**PLANNING DEPARTMENT
CITY OF CONWAY
COMMUNITY APPEARANCE BOARD MEETING
Wednesday, January 24, 2024 | 4:00 P.M.
Planning & Building Department – 196 Laurel Street**

- A. 1101 4th Ave (Stella's Ice Cream):** The applicant, Keith Powell of Stella's Ice Cream, is requesting conceptual review of a new walk in freezer for the business located at 1101 4th Ave. (PIN 367-01-01-0032).

DATE: January 24, 2024
ITEM: IV.A

1101 4th Ave (Walk in Freezer): The applicant, Keith Powell of Stella's Ice Cream, is requesting approval of a new walk in freezer for the business located at 1101 4th Ave. (PIN 367-01-01-0032).

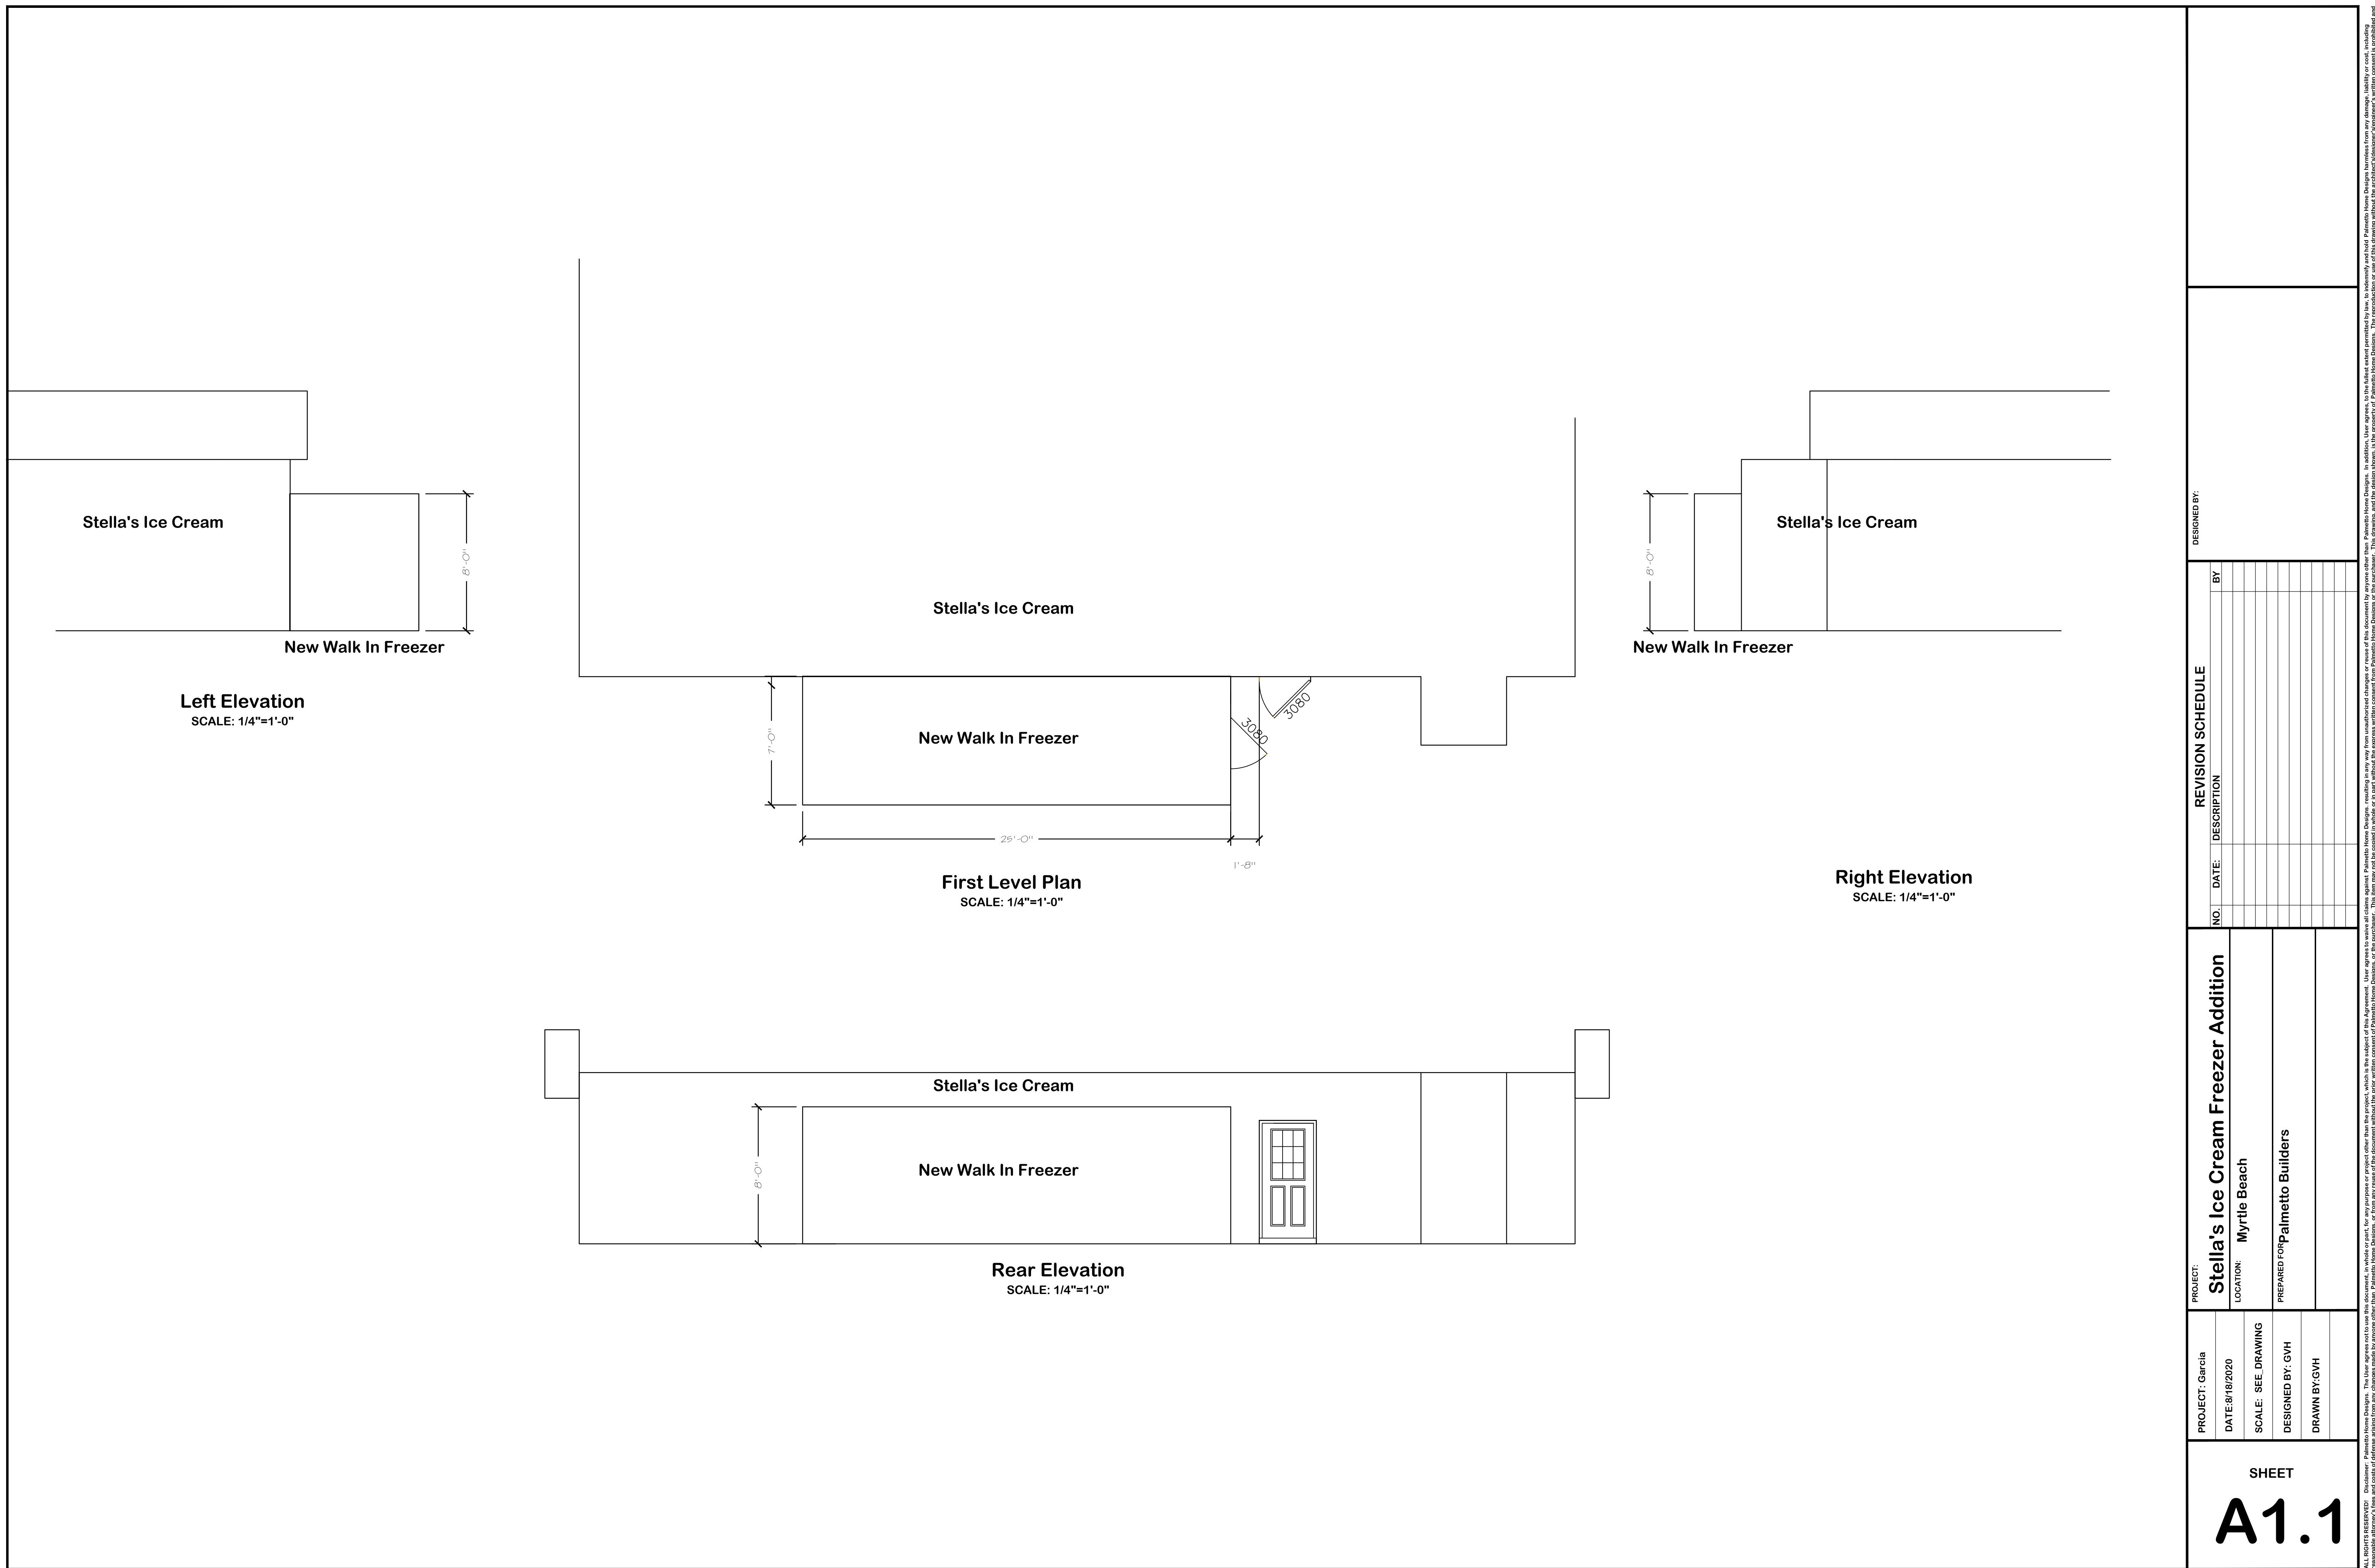
At the January 10th meeting the applicant board and staffed discussed the proposed location of the freezer. After discussions the applicant decided to attached the freezer to the existing building.

With the newly adjusted position of the structure. The proposed freezer will project past the side view of the building by about 1 foot.

The applicant provided a picture of a freezer that is similar to the one they have purchased. The picture provided shows a different color freezer, staff's understanding is that the freezer is silver not the off white as depicted in the picture provided.

In your own words, describe what you are requesting:			
Ref/Walk in freezer on back of building. Freezer will be attached			
to building. Unit will be painted white to match building. A 4-5 foot white vinyl fence 6' tall			
at end of bump out on plan if the freezer is to be visible from Laurel St
